Access Compliance Report

Public Rights-of-Way (Curb Ramps)

Intersection ID: N/A	Main Street: AGNEW_DR	Cross Street: PAMPLIN_CT	Location: NW
ADA ID: 75A4B2ABAB18	Ramp Type: Perp	Initial Pass/Fail: Fail	Overall Compliance: No
		Severity Score: 25

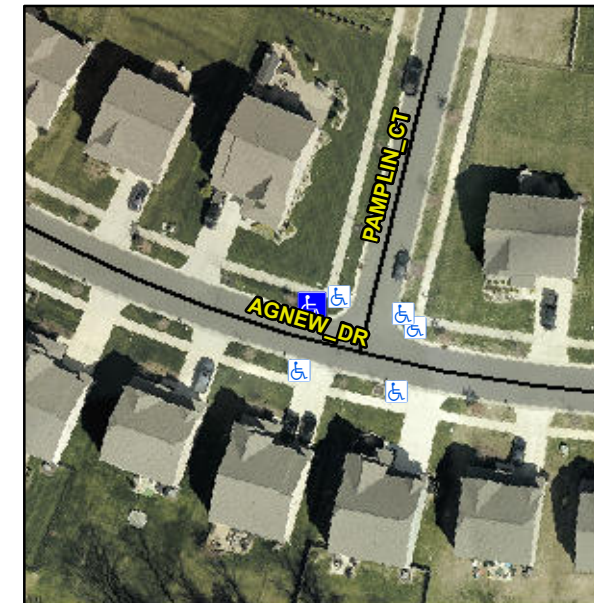
Not Found, R304.2.2

Compliance	Description	Data	Compliance	Description	Data
N/A	Ramp Length (in)	97.0	No	Ramp Slope (%)	13.2
Yes	Ramp Width (in)	48.0	Yes	Ramp XSlope (%)	1.0
N/A	Flare Type LT	N/A	N/A	Flare Type RT	N/A
N/A	Flare Slope LT (%)	N/A	N/A	Flare Slope RT (%)	N/A
N/A	Flare Traversable LT?	N/A	N/A	Flare Traversable RT?	N/A
N/A	Landing Length (in)	N/A	N/A	DWS Provided?	N/A
N/A	Landing Width (in)	N/A	N/A	DWS Contrast?	N/A
N/A	Landing Slope (%)	N/A	N/A	DWS Length (in)	N/A
N/A	Landing X Slope (%)	N/A	N/A	DWS Full Width?	N/A
N/A	Landing Curb? (Y/N)	N/A	N/A	DWS Offset (in)	N/A
N/A	Shared Landing?	N/A			
N/A	Gutter Ponding?	N/A	N/A	Gutter Slope (%)	N/A
N/A	Gutter Lip Ht (in)	N/A	N/A	Gutter X Slope (%)	N/A
N/A	Painted X Walk1?	No	N/A	Painted X Walk2?	N/A
	X Walk 1 Direction	To SW		X Walk 2 Direction	N/A
N/A	X Walk 1 Width (in)	N/A	N/A	X Walk 2 Width (in)	N/A
	X Walk 1 Slope (%)	4.8		X Walk 2 Slope (%)	N/A
	X Walk 1 X Slope (%)	2.0		X Walk 2 X Slope (%)	N/A

Remove & Replace Entire Ramp.
